Re: *Map Refinement Project Testimony regarding 2425 NW St. Helens Road*

SOILS INVESTIGATION AT TRUCK SITE ON ST. HELENS ROAD

TESTIMONY OF ROGER A. REDFERN BEFORE THE CITY OF
PORTLAND HEARINGS OFFICER REGARDING CU 64-89-
FTL SITE, 2425 N.W. ST. HELENS ROAD,
PORTLAND, OREGON, NOVEMBER 20, 1989

SITE PLAN

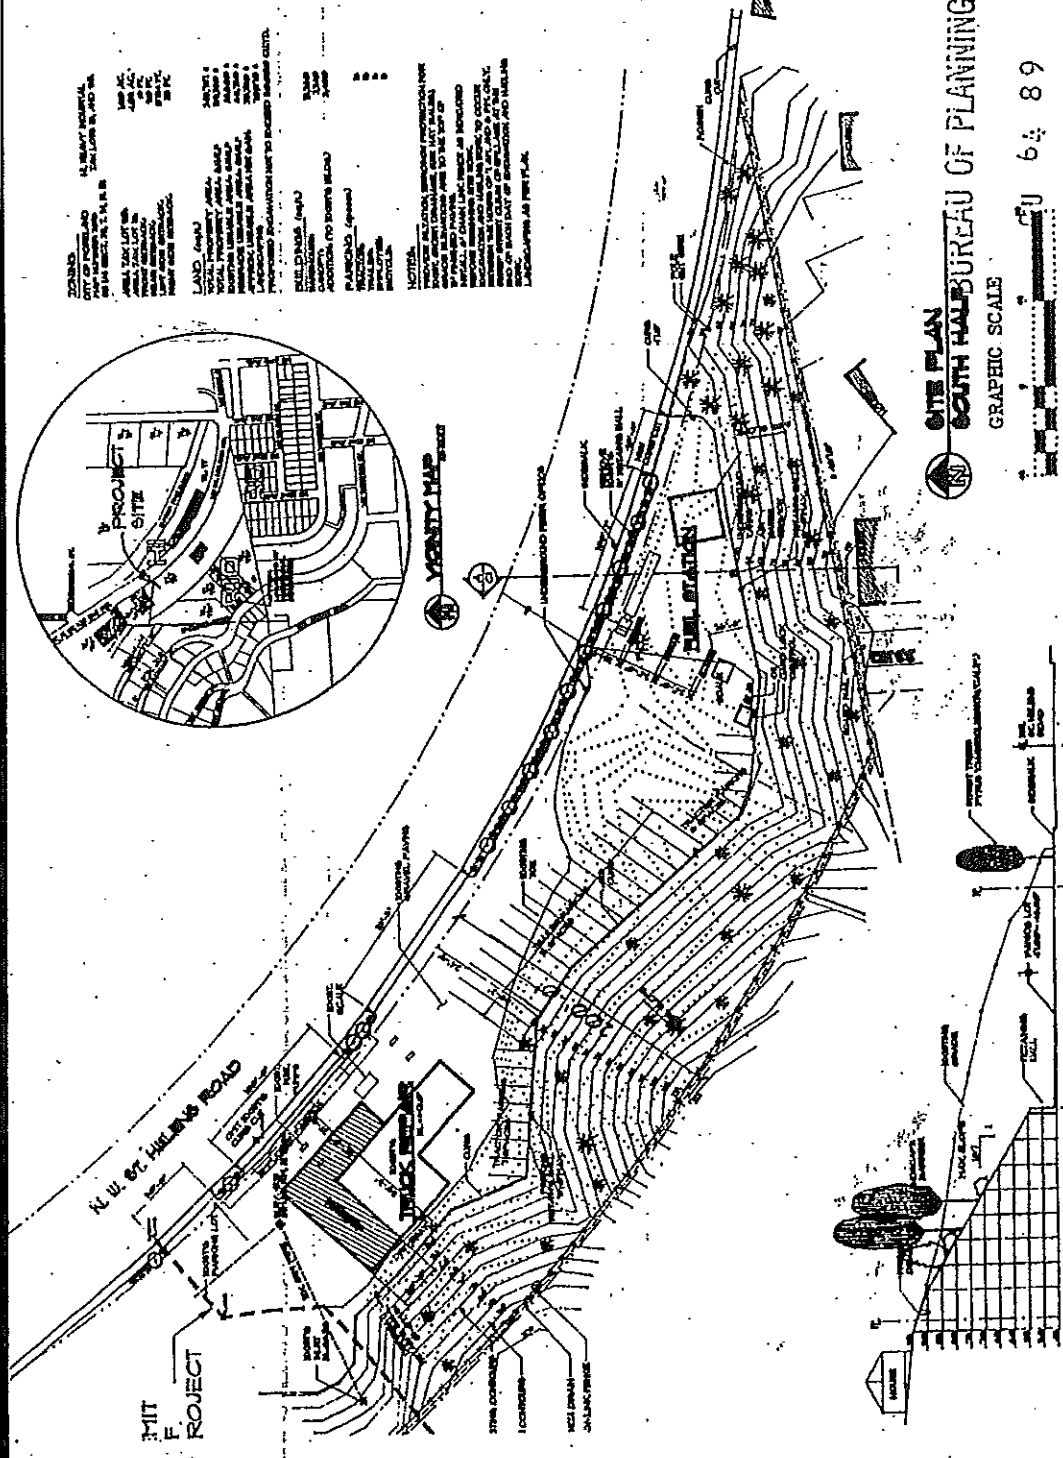
The applicants propose to excavate the hillside along the southwest side of St. Helens Road to create: 1) maneuvering area around existing truck repair building, 2) a site for a fueling station, and 3) parking areas for trucks and trailers in conjunction with the terminal at the north end of the property. The site created will be level with the existing NW St. Helens Road and will be paved. The volume of excavation is not to exceed 50,000 cubic yards according to the plans. The existing slope is to be reshaped from a 4:1 to a 60% slope and involves the installation of retaining structures at the base of the slope. The applicants propose to landscape and restore the newly cut slope. They indicate that the contractor will sweep the affected roadway at the end of each day to remove dirt. A 6-foot tall chain link fence along the southwest property line, bordering on the residential zone, will safeguard against children playing in the hazardous area. Construction operations will be limited to the hours of 7am to 6pm. The applicant states that the noise generated will be negligible when compared to ambient noise existing on and around NW St. Helens Road.

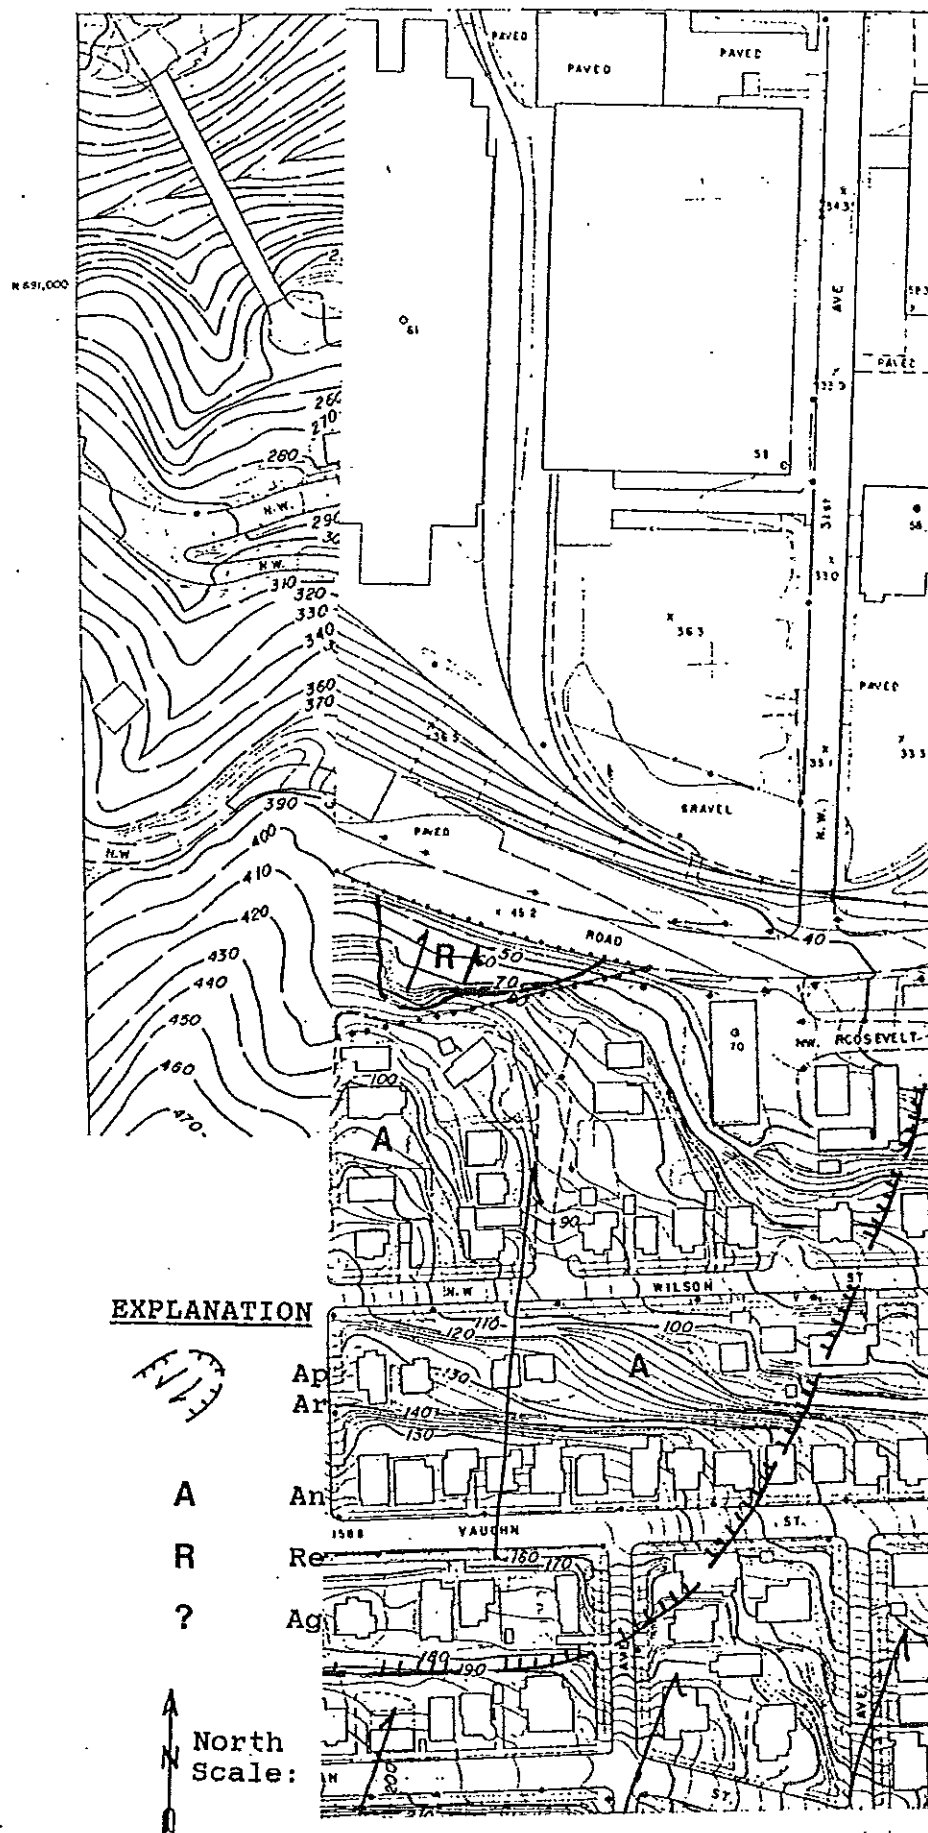
Many slope failures were found on this site and on adjacent property in my investigation. The majority of these failures are classified as landslides. With the limited time available it was not possible to make confident identifications on all of these existing failures. Where there was significant evidence those slides have been mapped (see the attached map).

The mapped slides include a massive, ancient landslide that includes the southern portion of the subject property, as well as a large developed area to the south and southeast. This slide probably resulted from erosion by the ancestral Willamette River or in the Missoula flood. Ancient landslides are generally defined as failures that are prehistoric or failed more than 100 years ago.

Two smaller, but still large, ancient landslides were found and mapped at the northern portion of the subject site. These slides have very strong (and definitive) topographic characteristics and are probably more recent than the massive slide area noted above. This slide was probably originally caused by erosion by the Willamette River at the toe (base) of the slope. Subsequent failure of a portion of the toe of the ancient landslides is suggested by old topographic mapping, but the slide area has been altered by excavation on the northern portion of the subject site and by excavation and building placement on the adjoining property to the north. The building to the north has been protected by a large retaining wall. That wall appears to adequately replace the failure resisting function of the portion of the toe of the ancient slide that was removed. Without this retaining wall the excavation for the building could have reactivated at least part of the ancient slide.

At the southern end of the subject property there is a landslide mapped as recent. The strong topographic features of this slide and the presence of a recently constructed retaining wall at the base of the slide are evidence of the recency of failure. This slide appears to have been caused by the removal of the toe of the slope (possibly a pre-existing landslide) by excavation for S.W. St. Helens Road.

There is a landslide mapped in the central portion of the southern half of this site. This slide is marked with a question mark (?) because of conflicting evidence regarding the age of failure. The topography of the upper portion of the slide indicates that it is ancient or at least inactive, but the presence of cross-slope valleys on the northern portion of the slide area indicate that a recent or active designation is appropriate. Further investigation is needed, but it appears that this is an inactive or ancient slide that has been partially reactivated as a result of excavation of the toe of the slide and is either slowly active or inactive.

I recommend that the application be denied at this time, and that the applicant conduct an appropriately detailed investigation to include mapping and analysis of existing landslides on the site and on adjacent property and to adequately characterize subsurface conditions on and above the site. Consideration should be given to drilling to sufficient depths in a subsurface investigation to identify landslide failure planes and ground water conditions.
